SUNDRY NOTICES AND REPORTS ON WELLS
Do not use this form for proposals to drill or to re-enter an abandoned well. Use Form 3160-3 (APD) for such proposals.

Sholes B-19 #4

RE: Plugging and Abandonment Requirements (Changes), Condition of Approval

Lease: Snodgrass B 19
Well #17

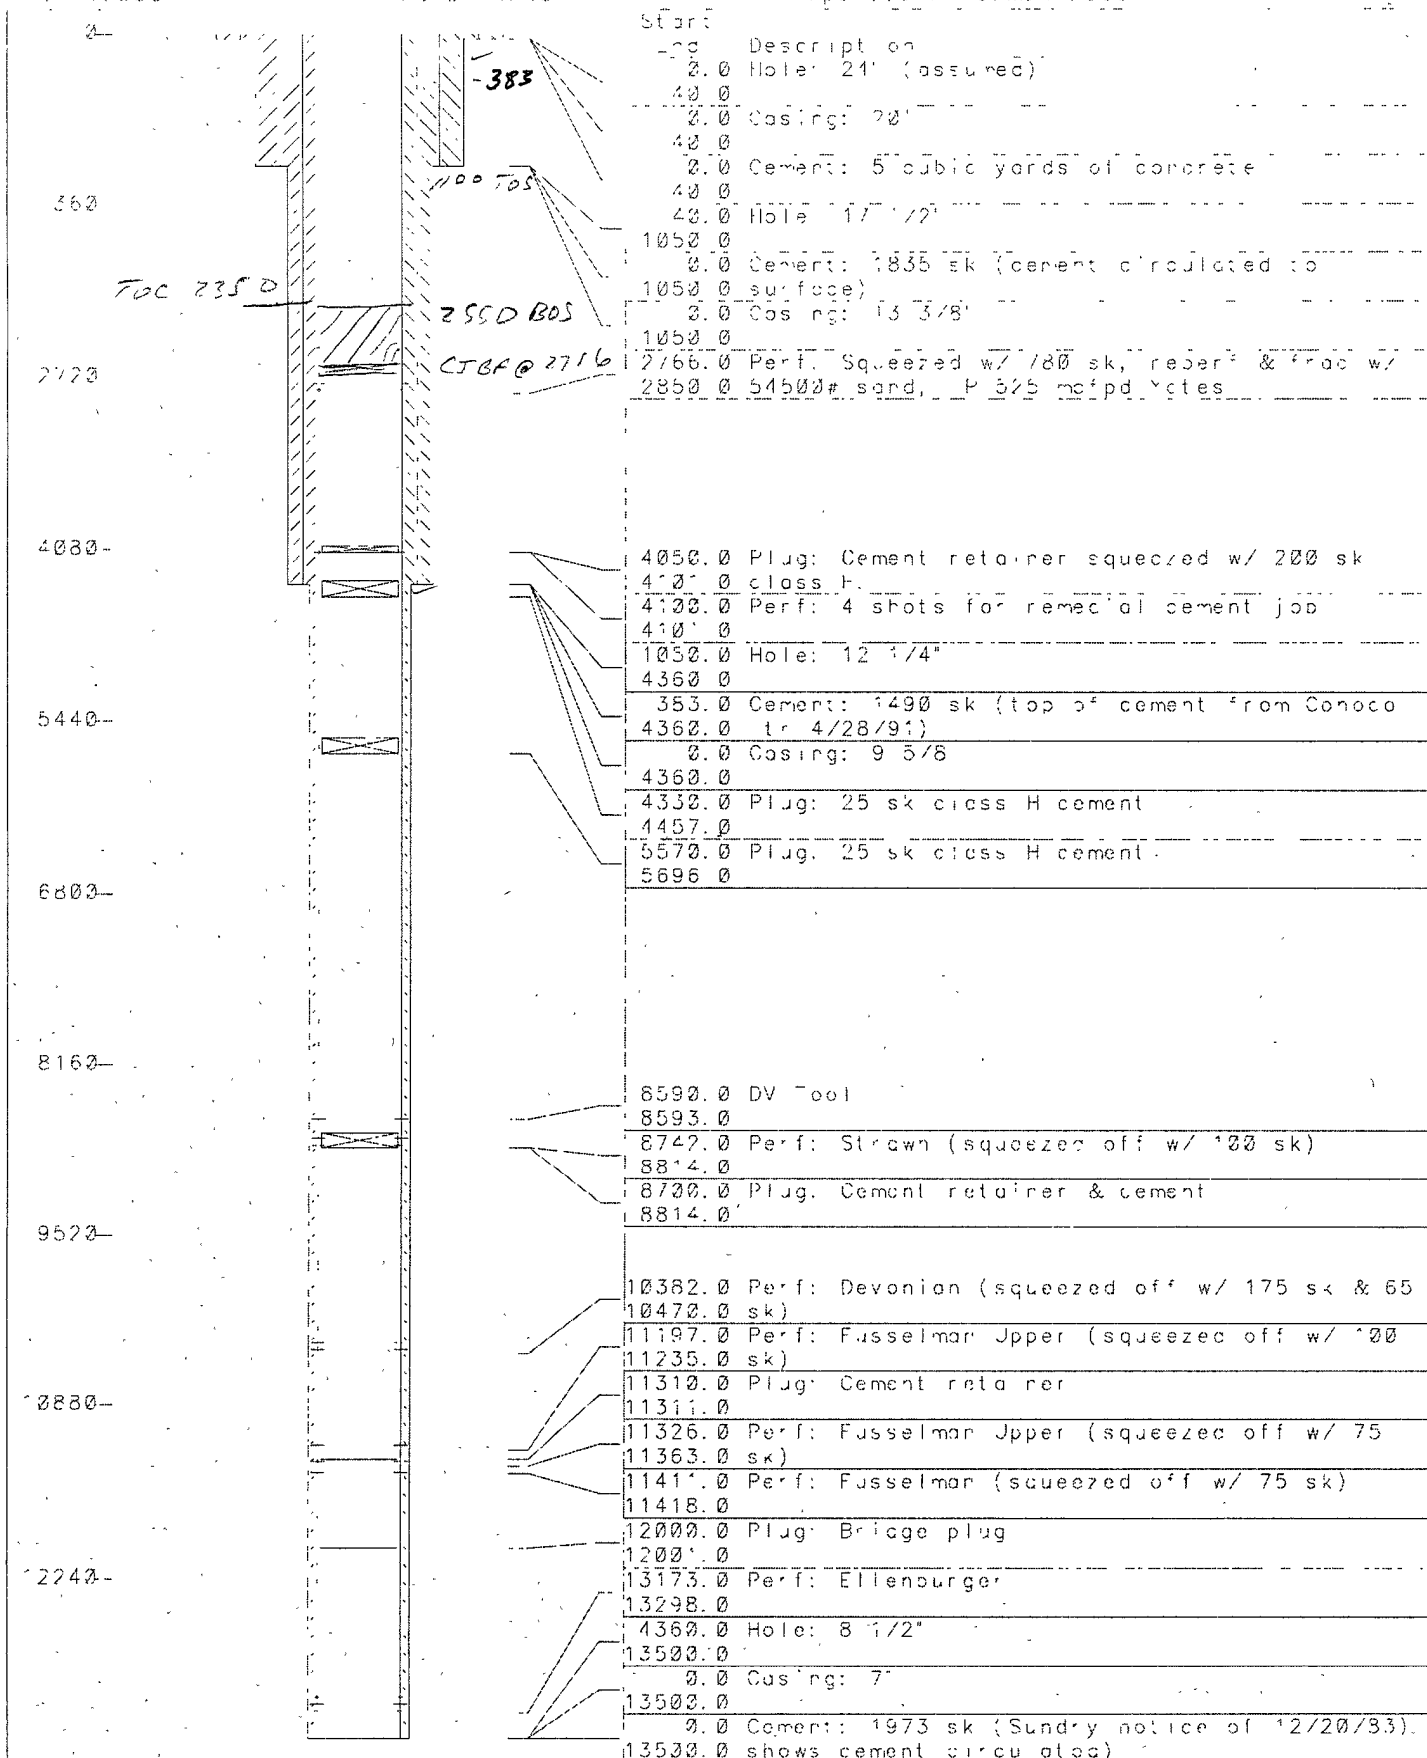
1. RIH and set a CIBP @ 2716'. Log casing with water run cement bond log.

2. Perforate the 7" casing @ 2715' and 2716' if necessary as as per BLM. Run tubing to 2715', spot 40 sk of cement on CIBP.

3. Pull tubing to 2715', spot 40 sk or squeeze w/ cement as per BLM. Pull tubing to 330', fill casing w/ cement. Pull tubing. Circulate cement to surface in/out of the 7" casing (covers the shoe and the surface plug).

4. Cut off the well head 3' below ground level, cap off all annulus from 50'-surface.

1. RIH and set CIBP @ 2716'. Cap w/ adequate cement to fill from 2716'-2500' (covers CIBP and Base of Salt).
2. Perforate the 7" casing @ 1150'. Attempt to squeeze adequate cement to fill from 1150'-1000' (covers shoe and Top of Salt). WOC and tag no lower than 1000'.
3. Perforate the 7" casing @ 330'. Attempt to circulate cement to surface in/out of the 7" casing.
4. Cut off the wellhead 3' below ground level, cap off all annulus from 50' to surface.
